**Product Support Bulletin N° PSB002**  
31 July 1997

**Ventura HUD Monitor Blanking Problem and Solution**

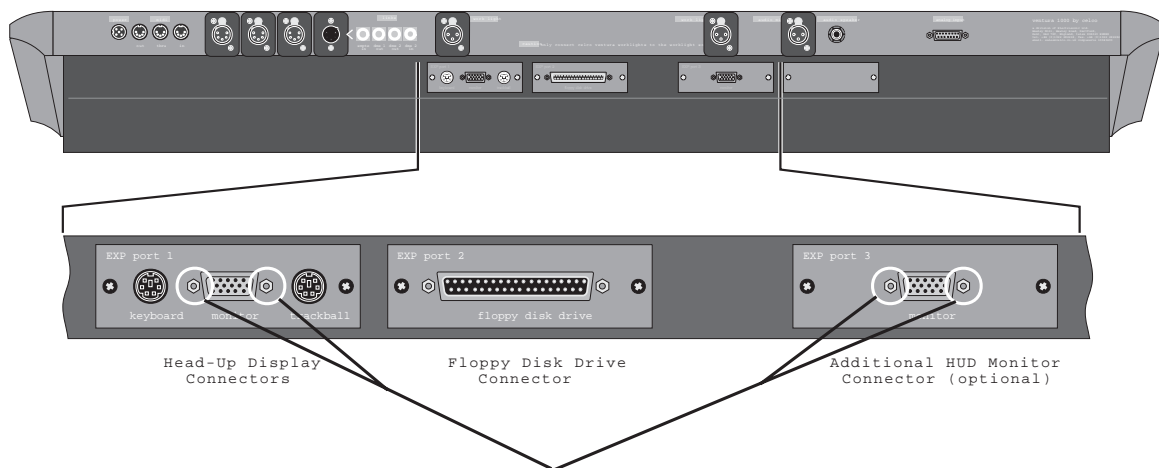
A small number of Ventura users have experienced problems with the monitor(s) blanking and locking up.

Investigation has revealed that this is being caused by a poor earth connection between the monitor connector and the mounting plate.

Fit shakeproof washers under these retaining screws

This is simply resolved by fitting shakeproof washers under the monitor cable retaining screws. The screws in question are marked on the attached drawing. The shakeproof washers should be fitted under each screw and to both connectors on a twin HUD version.
